# Race condition in 802.1Q-2018 between List Config state machine (clause 8.6.9.3) and Cycle Timer state machine (clause 8.6.9.1)

*Alon Regev*

*APRIL 15, 2021*

# Race Condition

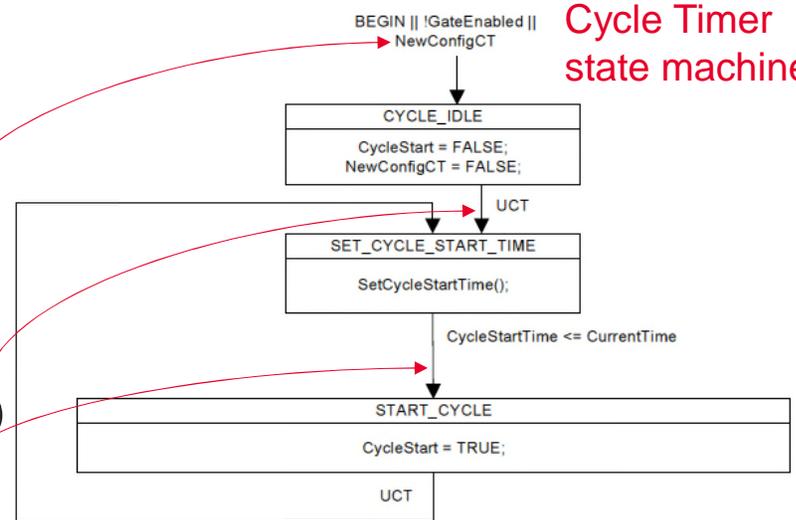
- In the List Config state machine (802.1Q-2018 clause 8.6.9.3), upon a ConfigChange (when GateEnabled is TRUE) ConfigPending is set to TRUE in the CONFIG\_PENDING state, remains TRUE in the UPDATE\_CONFIG state machine and is then set to FALSE in the CONFIG\_IDLE state.

- Also in the List Config state machine, in the UPDATE\_CONFIG state, NewConfigCT is set to TRUE. NewConfigCT being TRUE triggers the Cycle Timer state machine (802.1Q-2018 clause 8.6.9.1) to transition to the CYCLE\_IDLE state, which then transitions to the SET\_CYCLE\_START\_TIME (UCT). In the SET\_CYCLE\_START\_TIME state, the SetCycleStartTime() procedure determines which rules should be taken.

- Unfortunately, after the List Config state machine changes to the UPDATE\_CONFIG state, it is not clear if ConfigPending will be set to FALSE before or after the Cycle Timer state machine gets to the SET\_CYCLE\_START\_TIME state, hence the race condition.

# Affect on SetCycleStartTime() calculation

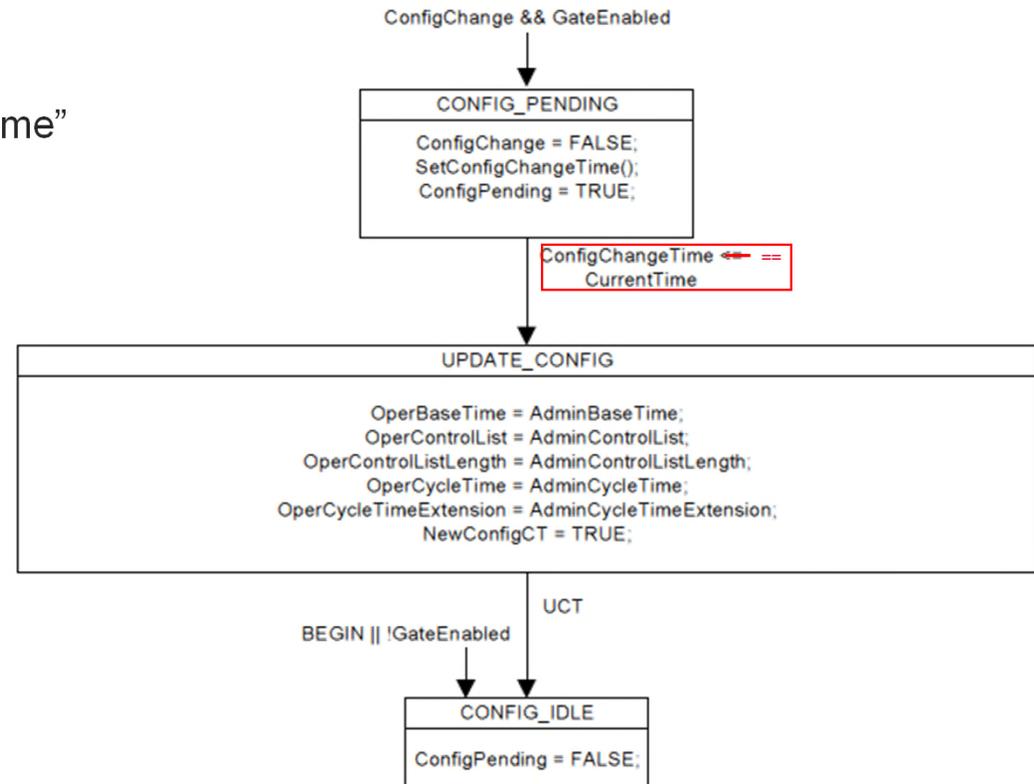
- This race condition only makes a difference to the outcome of the SetCycleStartTime() calculation when:
  - A dynamic schedule change is done (applying a new gate control list while another one is already running)

- In the List Config state machine, the transition from CONFIG\_PENDING to UPDATE\_CONFIG occurs when ( $\text{ConfigChangeTime} < \text{CurrentTime}$ )

- the problem doesn't occur if the transition occurs when  $\text{ConfigChangeTime}$  is equal to  $\text{CurrentTime}$
- This is the behavior of the SetCycleStart() calculation after the List Config state machine under the two cases:

- if the Cycle Timer state machine is run before ConfigPending is set to FALSE:
    - ConfigPending is TRUE
    - " $\text{ConfigChangeTime} \leq (\text{CurrentTime} + \text{OperCycleTime} + \text{OperCycleTimeExtension})$ " must be true as  $\text{ConfigChangeTime} \leq \text{CurrentTime}$

- this was required in the transition from the CONFIG\_PENDING to the UPDATE\_CONFIG in the List Config state machine
    - Therefore, the SetCycleStart() will use rule "d)" and set  $\text{CycleStartTime} = \text{ConfigChangeTime}$

- if the Cycle Timer state machine is run after ConfigPending is set to FALSE:
    - ConfigPending is FALSE
    - At this point,  $\text{CurrentTime} \geq \text{ConfigChangeTime} \geq \text{OperBaseTime}$  ( $\text{ConfigChangeTime}$  is set  $\geq \text{AdminBaseTime}$  in the SetConfigChangeTime() function;  $\text{OperBaseTime}$  was set  $\text{AdminBaseTime}$  in the UPDATE\_CONFIG state of the List Config state machine; and  $\text{CurrentTime} \geq \text{ConfigChangeTime}$  as this was required in the transition from the CONFIG\_PENDING to the UPDATE\_CONFIG in the List Config state machine)

- The question is whether  $\text{CurrentTime} > \text{OperBaseTime}$  or  $\text{CurrentTime} == \text{OperBaseTime}$ :
      - If ( $\text{ConfigPending} = \text{FALSE}$ , and  $\text{OperBaseTime} \geq \text{CurrentTime}$ )

- $\text{CycleStartTime} = \text{OperBaseTime} = \text{AdminBaseTime}$
      - If ( $\text{ConfigPending} = \text{FALSE}$ , and  $\text{OperBaseTime} < \text{CurrentTime}$ )

- $\text{CycleStartTime} = (\text{OperBaseTime} + N * \text{OperCycleTime})$ , where N is the smallest integer for which  $\text{CycleStartTime} \geq \text{CurrentTime}$

- If  $\text{CurrentTime} > \text{OperBaseTime}$  (which will occur if the transition from CONFIG\_PENDING to UPDATE\_CONFIG in the List Config state machine occurs when  $\text{ConfigChangeTime} < \text{CurrentTime}$ ) then the cycle will only start  $N * \text{OperCycleTime}$  after  $\text{OperBaseTime}$  essentially not starting a cycle (and not running any gates) for  $N * \text{OperCycleTime}$
